A RESOLUTION RECEIVING ADDITIONAL PUBLIC COMMENTS AND
TAKING FURTHER ACTION ON A REVISED DESIGN FOR
SMITH LEVEL ROAD IMPROVEMENTS
RESOLUTION NO. 25/2010-11

MEMORANDUM

RE: Smith Level Road (TIP #U-2803): September 28 public hearing
continuation

Figure 1. Map of Smith Level Rd. between BPW Club Rd. and Willow Oak Ln. Bus stop locations are approximate. At this time, a short sidewalk segment serves the bus stop at University Commons.

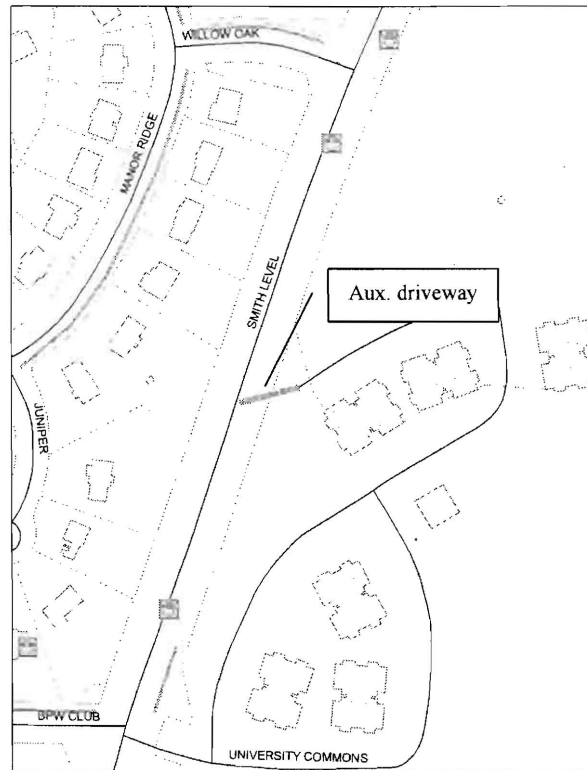
The Board of Aldermen inquired about the possibility of removal from the revised design

of a proposed sidewalk of approximately 930 ft. extending from the bus stop at the main University Commons driveway to a future crosswalk at Willow Oak, in exchange for a sidewalk on the east side, south of Woodcrest.

A question was raised at the June 16 TAB meeting: instead of building a whole sidewalk from Willow Oak to the University Commons driveway bus stop, could something less than that be built – such as only a landing or concrete pad for the northbound Willow Oak bus stop – that would be enough to anchor the proposed crosswalk north of Willow Oak but would not extend south? It was pointed out that new marked crosswalks on Martin Luther King, Jr., Blvd. in Chapel Hill connect to bus stops that are not accessed by contiguous sidewalks. In general, a crosswalk may be possible in the absence of a contiguous sidewalk – as long as ADA guidelines related to bus stops and pedestrian crossings were met. However, pedestrians who choose to walk on the east side of the road would not be accommodated by a sidewalk.

Given the updated cost estimate for the Town's share of sidewalks, which is \$54,772, and the fact that the sidewalk on the east side of the road from Willow Oak Ln. to University Commons bus stop is about 11 percent of the total length of proposed sidewalks, it is estimated that the Town would save about \$6,000 from omitting this sidewalk from the plans.

Staff recommends that the sidewalks be retained as proposed in the design.

Figure 3. GIS representation of municipal boundaries near Smith Level Rd. and Woodcrest Dr.

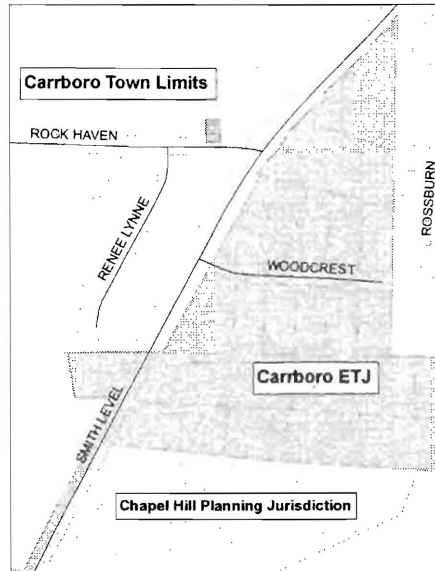
As discussed at the Sept. 7 continuation, NCDOT has modified the design to include a sidewalk connection south of Woodcrest on the west side of Smith Level but has not felt it warranted to include a sidewalk on the east side. Woodcrest is the nearest intersection north of the beginning of the project. Unlike on the high school property on the west side, there is no sidewalk on the east side with which to further connect. The grade leading up to the roadway is >30%. Tying the grade in to include a sidewalk may require additional ROW and cost. In 2000, the area south of Woodcrest within Carrboro's ETJ had a population of 10.

According to GIS data, the Carrboro Town limits extend about 340 ft. south of Woodcrest Dr., including the current Smith Level Rd. ROW. The Carrboro ETJ extends another ~340 ft. south of Woodcrest on the east side. Beyond that is Chapel Hill's Planning Jurisdiction (Figure 3). Chapel Hill's Greenway Master Plan suggests a potential greenway link from Southern Village to Smith Level Rd. just south of Ray Rd. The plan states: "It might be possible to provide a link from the Fan Branch Trail in Southern Village in Chapel Hill to the Chapel Hill/Carrboro City Schools third high school site in Carrboro."⁵ Chapel Hill planning staff have indicated that there is currently no funding or timeline for the development of this connection.
